THE ESSELTINE DRAIN: ADDENDUM REPORT—BOOK 3

SECOND ONSITE MEETING 25 JANUARY 2017
LANDOWNER QUESTIONS AND COMMENTS

RC SPENCER ASSOCIATES INC.
Consulting Engineers

Project No.: 14-425

Figure 5: Joni Baltzer – Ravine Cross Section

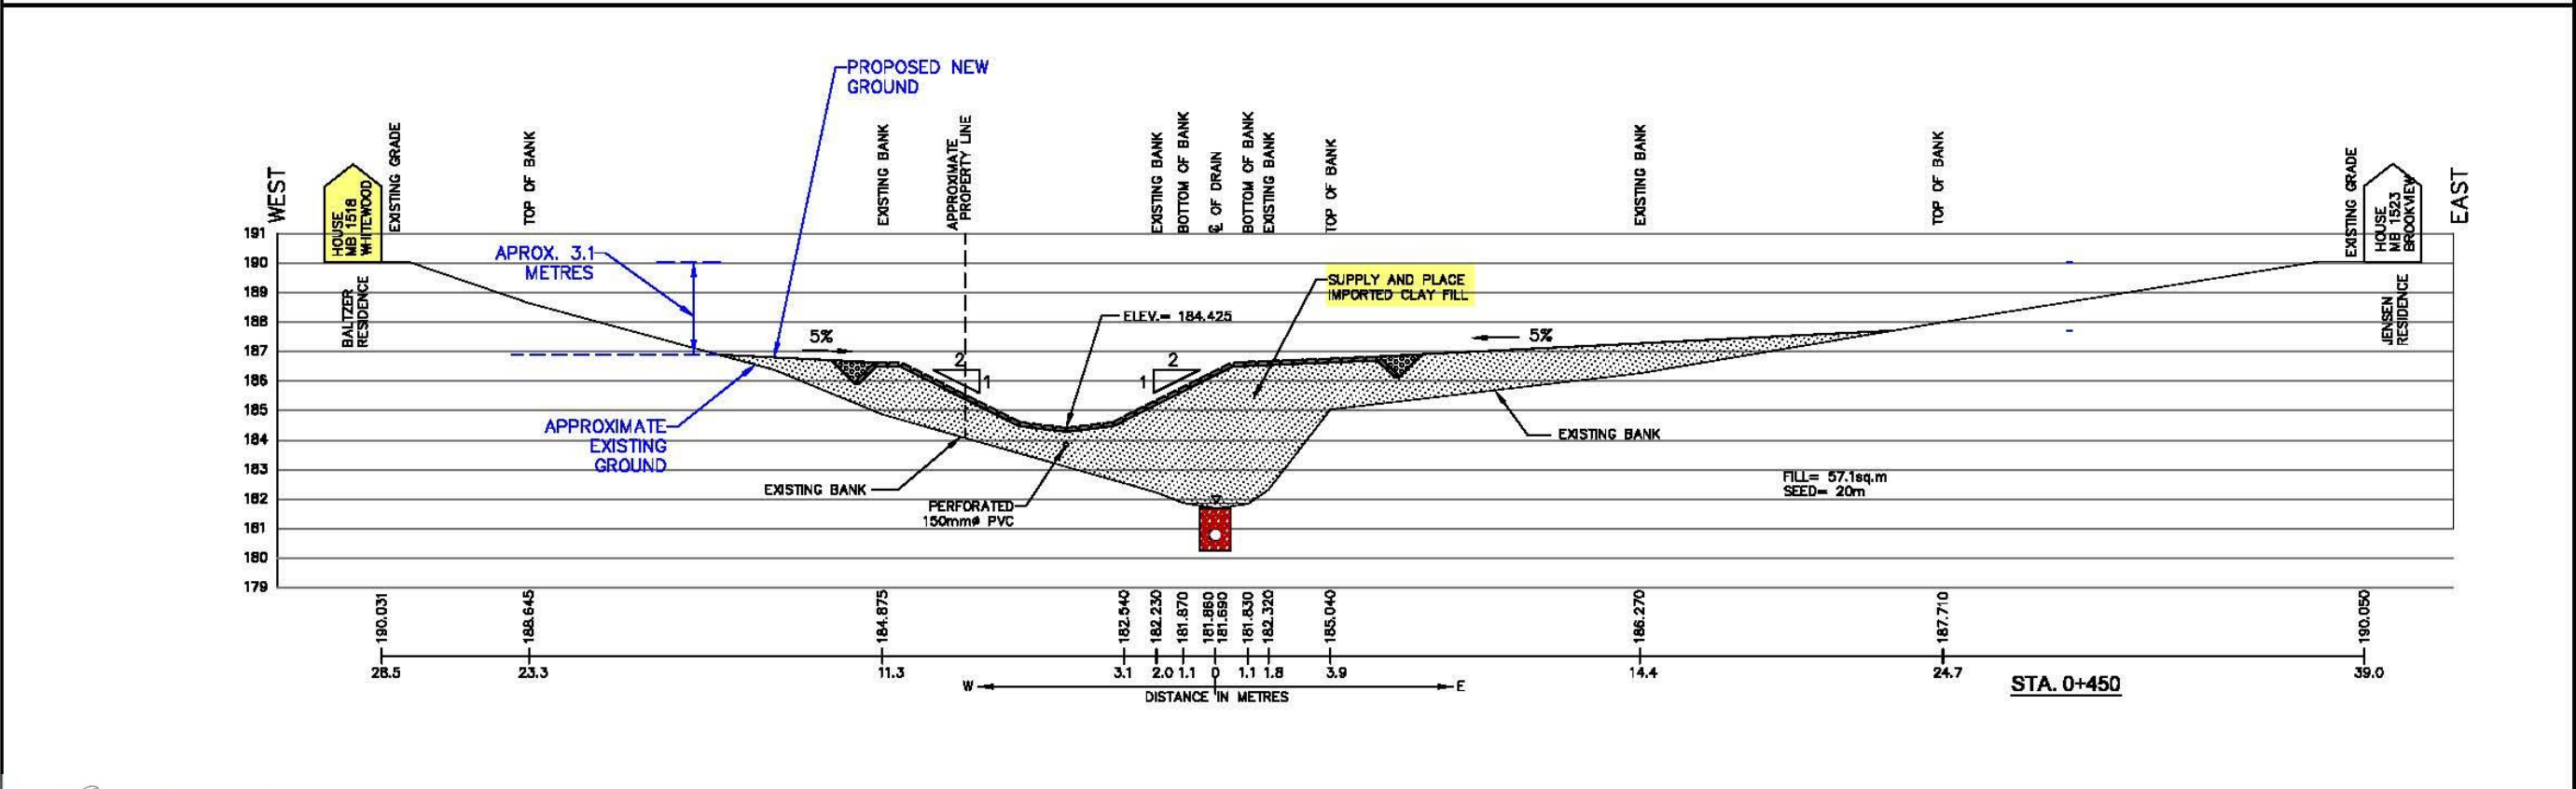
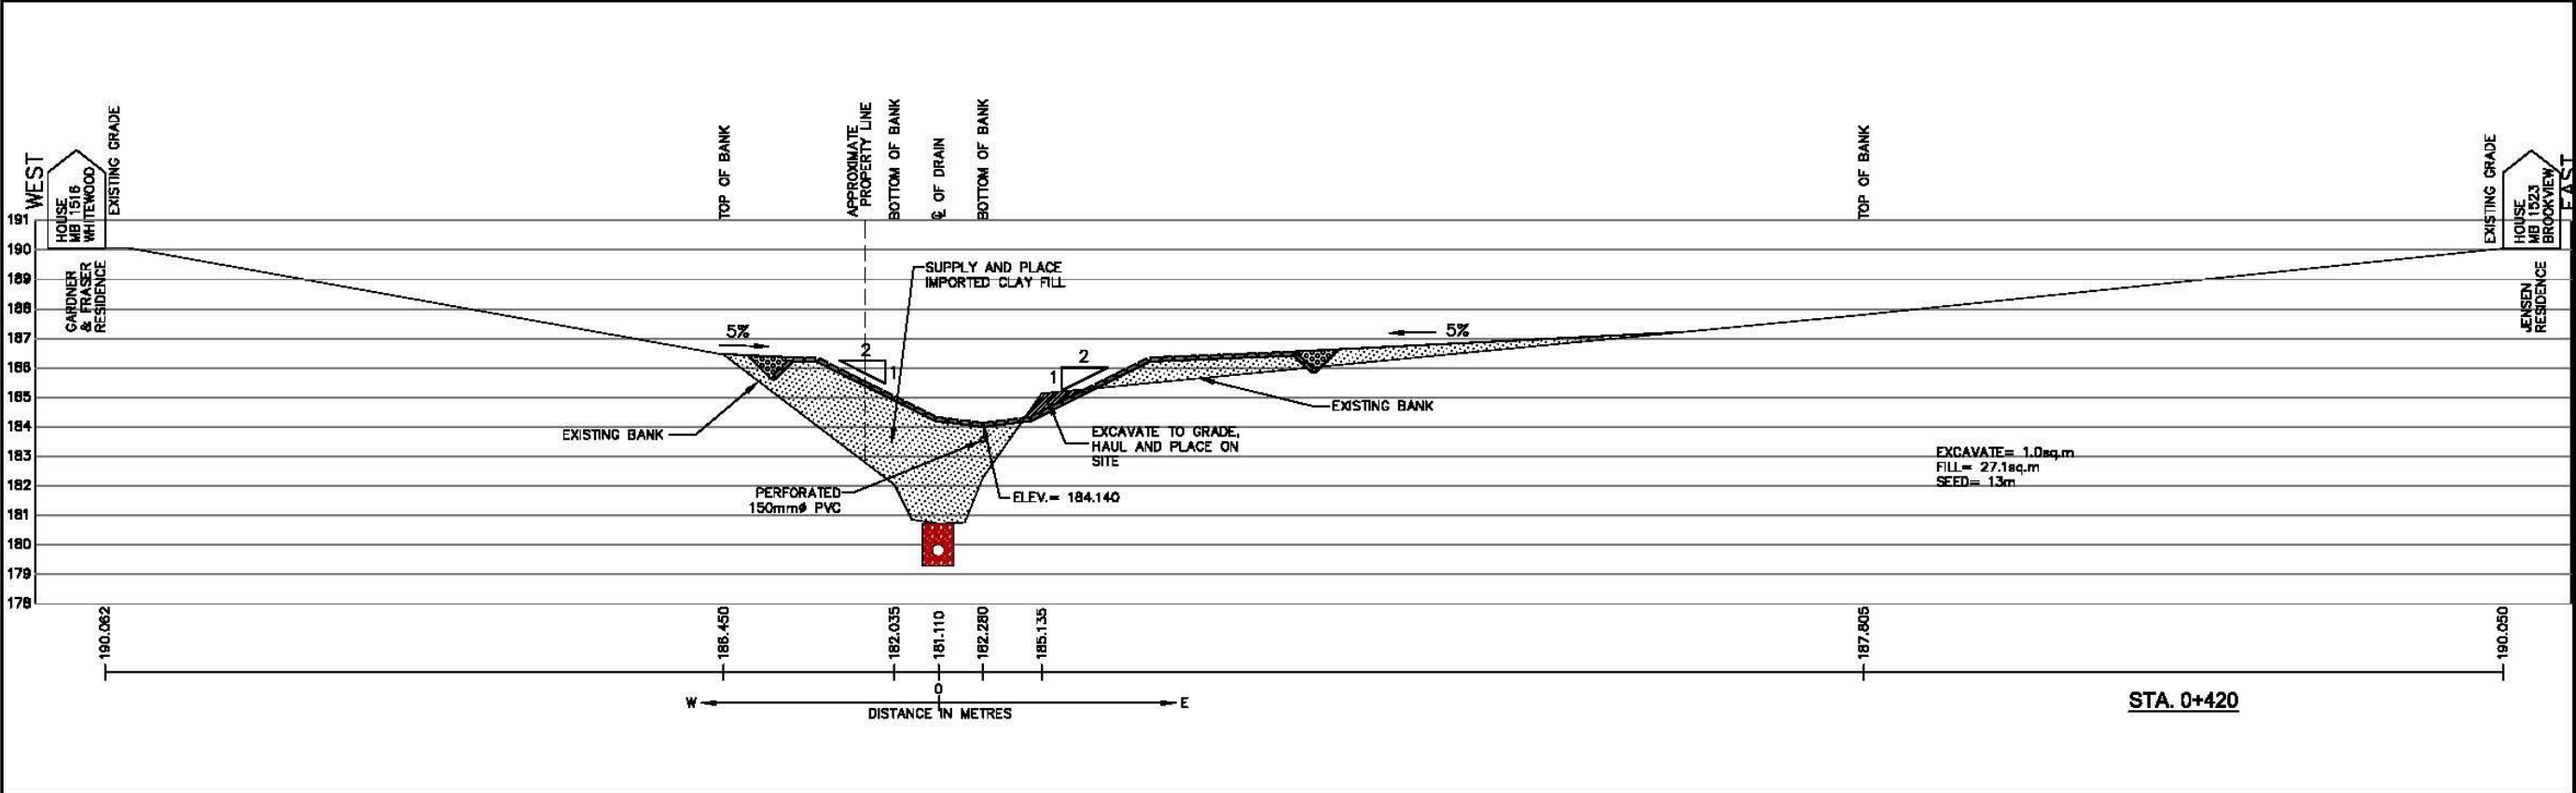
9)	Joni Baltzer 1518 Whitewood Road Roll No.: 300-29324	January 25, 2017	1) How much will the drain be raised, how much earth fill? 2) How high is the elevation of the cable concrete going to be relative to my property?	1) a) The bottom of the existing drain will be raised 2-4m along the ravine area. There will be an outlet weir at Lake Erie where the water drops off. b) Attached is a cross-section showing the approximate conditions at your property and proposed height of the cable concrete. (Cross-section at the bottom of the sheet attached) 2) The sheet attached shows the cable concrete relative to your house. The bottom of the drain or the center of the cable concrete will be around 5.6m below the finished grade of your house. - Please see page 14 (Figure 5) for attachment
